## ORIGINATION FORM

### Proposed Revisions to a Standard Plans Index

Index Number: 455-400

Index Title: Precast Concrete Sheet Pile Wall  
(Conventional)**Summary of the changes:**

**SECTION THRU BULKHEAD**

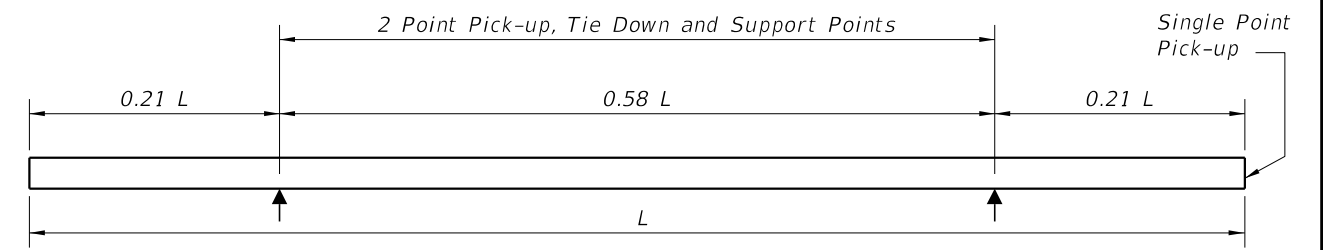
Sheet 1: Changed the "PLASTIC FILTER FRABRIC" Note in the SHEET PILE DESIGN CRITERIA AND NOTES to "GEOTEXTILE: Provide and install Type D-2 or D-3 geotextile in accordance with Specifications 514. Extend the geotextile to the bottom of the "X" dimension."; Changed all references of "Filter Fabric" or "Plastic Filter Fabric" to "Geotextile".

**CHANGED: Geotextile**

Plastic Filter Fabric  
(Continuous)

(Showing Plastic Filter Fabric)

**CHANGED:**  
Provide and install Type D-2 or D-3 geotextile in accordance with Specifications 514. Extend the geotextile to the bottom of the "X" dimension.
